FIFC report

Junji Haba

IPNS, KEK

KL and K1.1 beam line

2. K_L Measurement

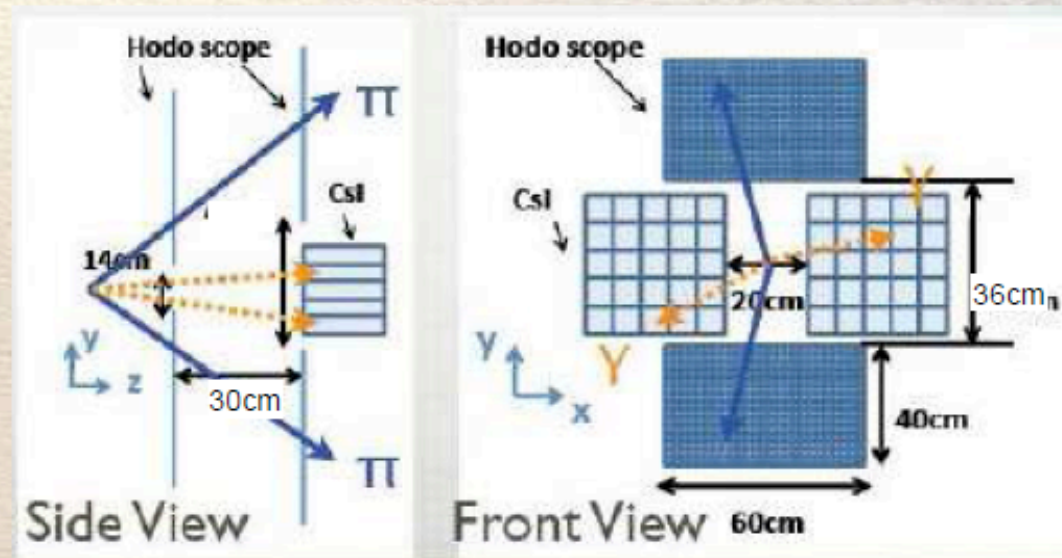
- “No redundancy measurement”
 - Kinematics just determined by all the measurements other than KL mass constraint
 - Very little tolerance for background hit. Stability against background is not clear.
- Independent check/ measurement of acceptance/ efficiency seems important.
- Stability /monitor of primary beam condition (intensity, position, time structure ...) is essential. Not yet been investigated fully.

Earth fault found in the TOSHIBA factory (July)

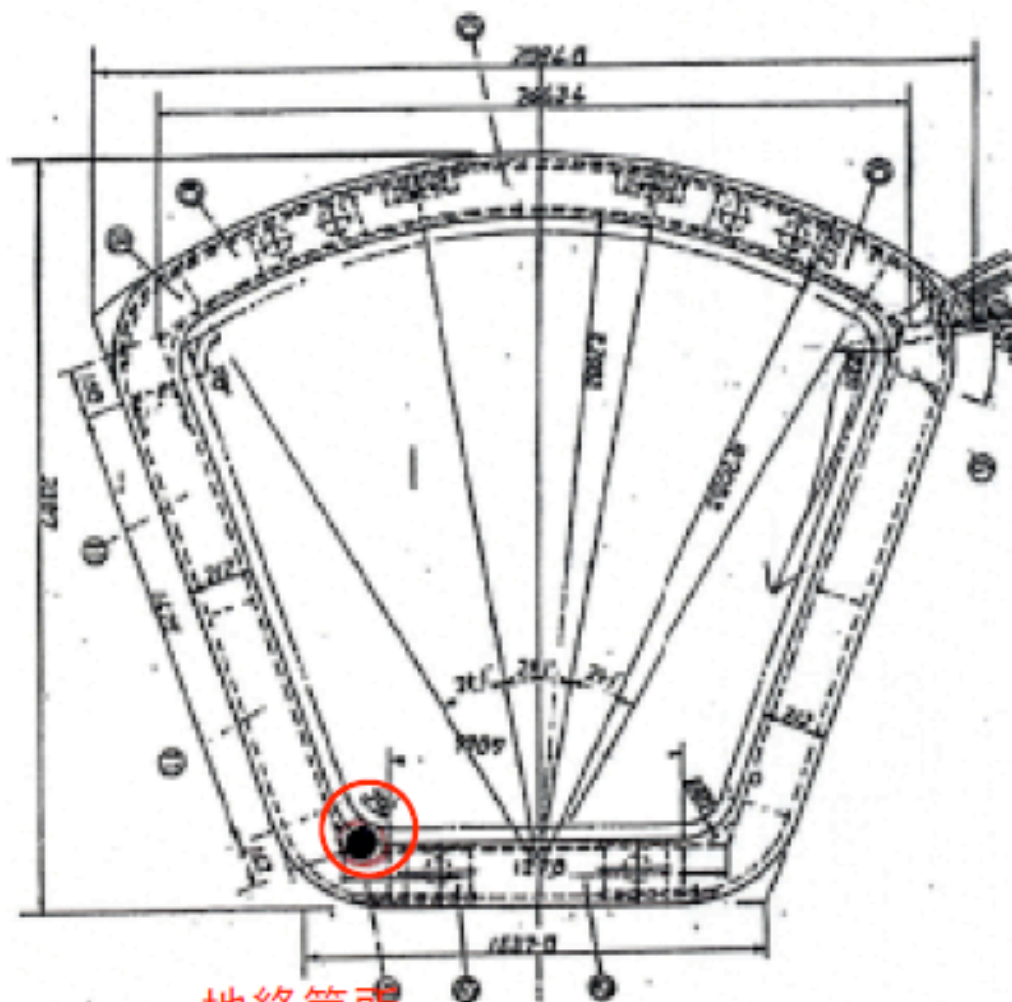
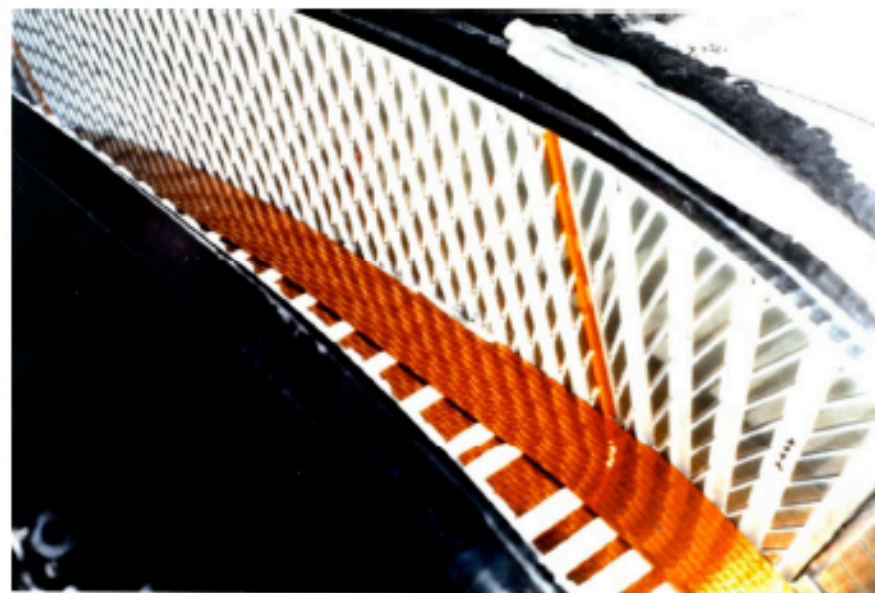
- Cause of the trouble not identified.
- Renovation and test are reasonable.
- Preparation is necessary for future happening of another earth fault.
- Thanks to the new refrigerator system, thermal cycling can be much less frequent. (regulation framework can be changed for simpler operation/shift)
